Entergy Nuclear Operations, Inc.
Palisades Nuclear Plant
27780 Blue Star Memorial Highway
Covert, MI 49043
Tel 269 764 2000

Palisades Nuclear Plant
Docket 50-255
License No. DPR-20

License Amendment Request for Spent Fuel Pool Region I Criticality

ENCLOSURE 1
LICENSE AMENDMENT REQUEST FOR
SPENT FUEL POOL REGION I CRITICALITY
DESCRIPTION OF REQUESTED CHANGES

Fuel Loading Pattern for Region 1A

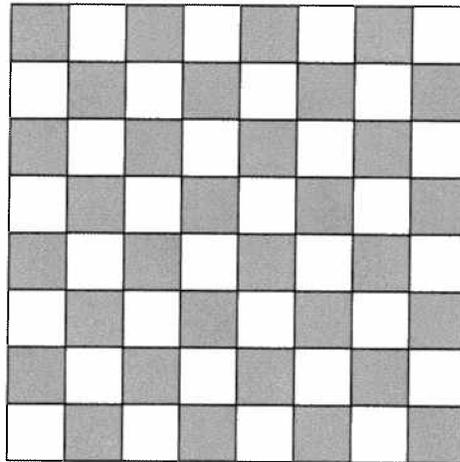
New TS 4.3.1.1f would be added and read as follows:

“Region 1A is defined as the Region I storage racks located in the main spent fuel pool and are subject to the following restriction. All fuel located in Region 1A shall be in a two-of-four checkerboard loading pattern with empty cells as shown in the figure below. Region 1A fuel is limited to those assemblies having a nominal planar average U-235 enrichment of less than or equal to 4.54 weight percent. Region 1A shall not contain any face adjacent fuel assemblies. Restrictions for non-fissile bearing components are described in section 4.3.1.1j below;”

Region 1B Patterns for Four or Fewer Face Adjacent Assemblies in a Row

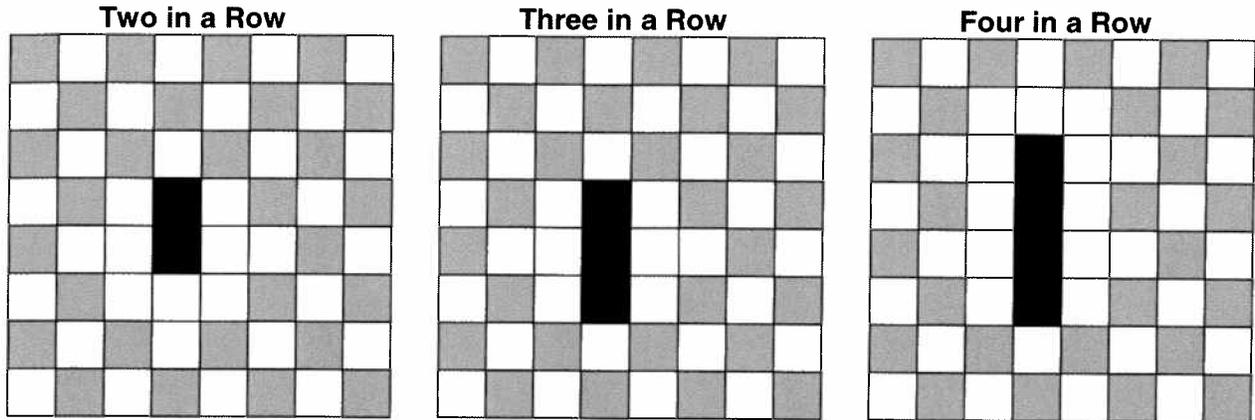
“Region 1B is defined as the Region I storage racks located in the main spent fuel pool with face adjacent fuel that is surrounded by empty face adjacent cells. Region 1B fuel is limited to those assemblies having a nominal planar average U-235 enrichment of less than or equal to 4.34 weight percent. Region IA cells that are diagonally adjacent to Region 1B may contain fuel assemblies provided conditions of Section 4.3.1.1f, 4.3.1.1g.1 and 4.3.1.1g.2 are met. Restrictions for non-fissile bearing components are described in section 4.3.1.1j below. Additional geometric conditions on Region 1B are:

1. Up to four face adjacent fuel assemblies in a single contiguous row are allowed as shown in the figures below. All other face adjacent cells shall be empty or contain non-fissile bearing components as described in section 4.3.1.1j below.

Region 1B Patterns for Three in an L

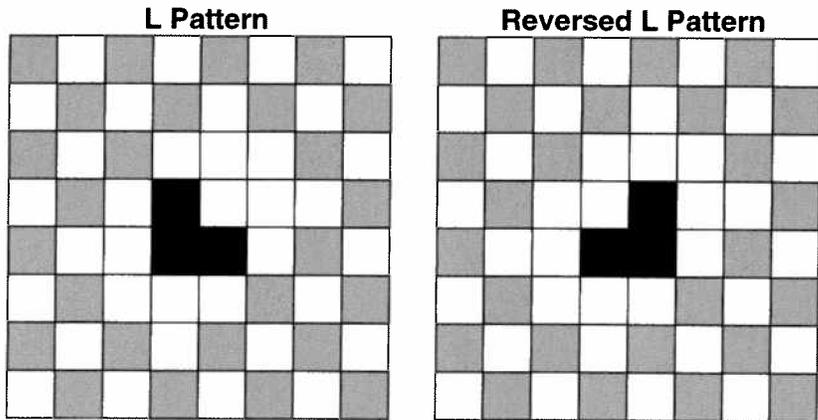
2. Three face adjacent fuel assemblies forming an L pattern are allowed as shown in the figures below. All face adjacent cells surrounding the two-by-two block containing the L pattern shall be empty or contain non-fissile bearing components as described in section 4.3.1.1j below;”

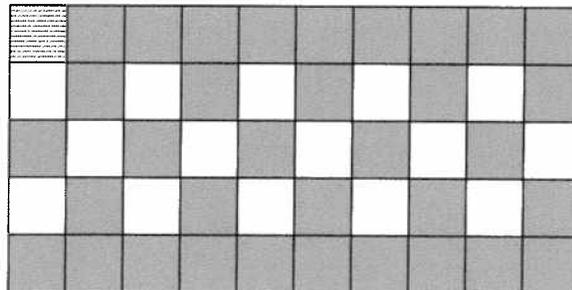
New TS 4.3.1.1h would be added and read as follows:

“Interface Requirements for the Main Spent Fuel Pool

1. Region I fuel racks that have cells that occupy locations F24 through U24 of the Main Spent Fuel Pool are adjacent to fuel racks in Region II of the Main Spent Fuel Pool. These cells shall be loaded with at least one empty cell between each fuel assembly within this group of cells.

Fuel Loading Pattern for Region 1A

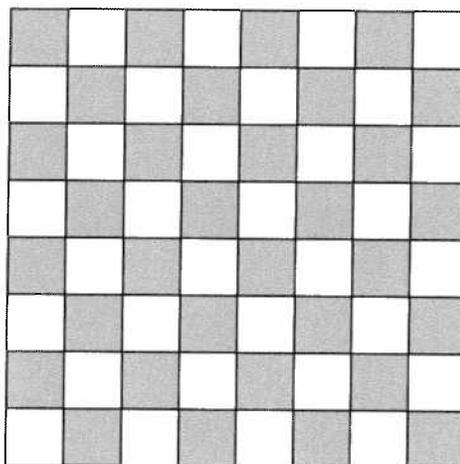
- f. Region 1A is defined as the Region I storage racks located in the main spent fuel pool and are subject to the following restriction. All fuel located in Region 1A shall be in a two-of-four checkerboard loading pattern with empty cells as shown in the figure below. Region 1A fuel is limited to those assemblies having a nominal planar average U-235 enrichment of less than or equal to 4.54 weight percent. Region 1A shall not contain any face adjacent fuel assemblies. Restrictions for non-fissile bearing components are described in section 4.3.1.1j below;

Region 1B Patterns for Four or Fewer Face Adjacent Assemblies in a Row

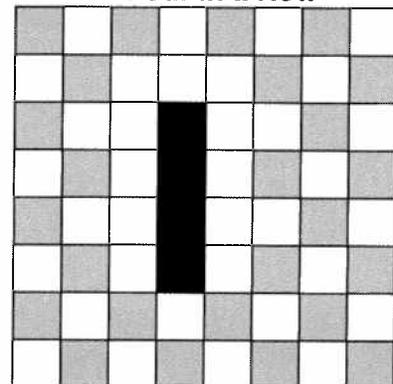
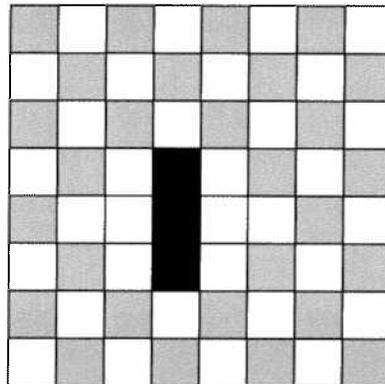
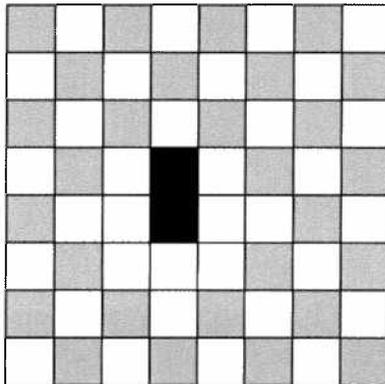
g. Region 1B is defined as the Region I storage racks located in the main spent fuel pool with face adjacent fuel that is surrounded by empty face adjacent cells. Region 1B fuel is limited to those assemblies having a nominal planar average U-235 enrichment of less than or equal to 4.34 weight percent. Region IA cells that are diagonally adjacent to Region 1B may contain fuel assemblies provided conditions of Section 4.3.1.1f, 4.3.1.1g.1 and 4.3.1.1g.2 are met. Restrictions for non-fissile bearing components are described in section 4.3.1.1j below. Additional geometric conditions on Region 1B are:

1. Up to four face adjacent fuel assemblies in a single contiguous row are allowed as shown in the figures below. All other face adjacent cells shall be empty or contain non-fissile bearing components as described in section 4.3.1.1j below.

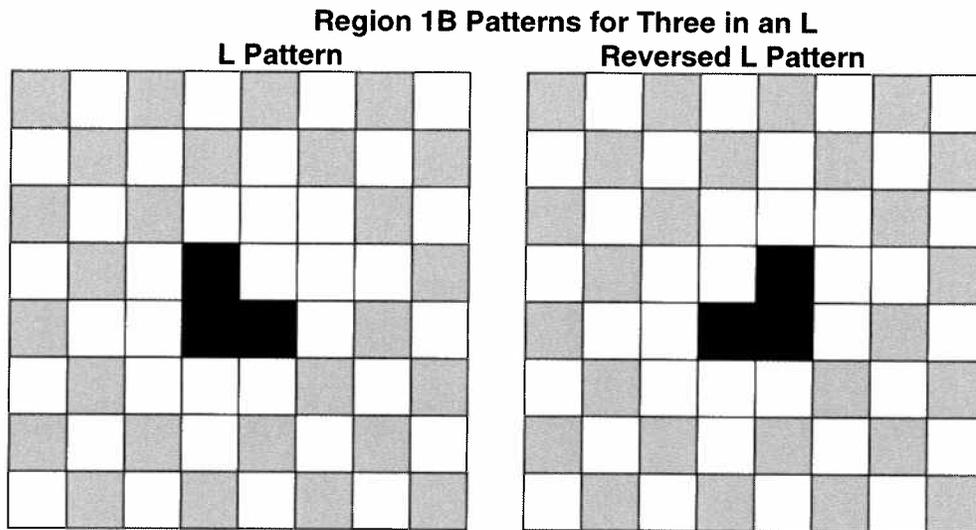
2. Three face adjacent fuel assemblies forming an L pattern are allowed as shown in the figures below. All face adjacent cells surrounding the two-by-two block containing the L pattern shall be empty or contain non-fissile bearing components as described in section 4.3.1.1j below;

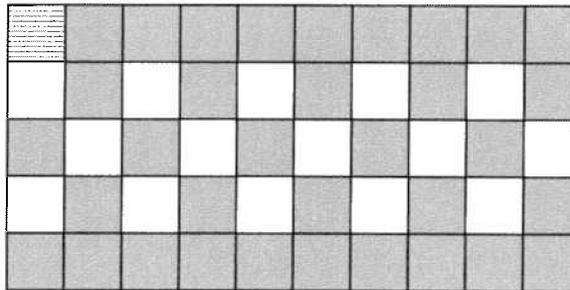
- h. **Interface Requirements for the Main Spent Fuel Pool**
 1. Region I fuel racks that have cells that occupy locations F24 through U24 of the Main Spent Fuel Pool are adjacent to fuel racks in Region II of the Main Spent Fuel Pool. These cells shall be loaded with at least one empty cell between each fuel assembly within this group of cells.
 2. There are twelve locations adjacent to the area that contains the elevator and inspection station. These locations are I1, I2, I3, J3, K3, L3, M3, N3, O3, P1, P2, and P3. These cells shall be loaded with at least one empty cell between each fuel assembly within this group of cells;
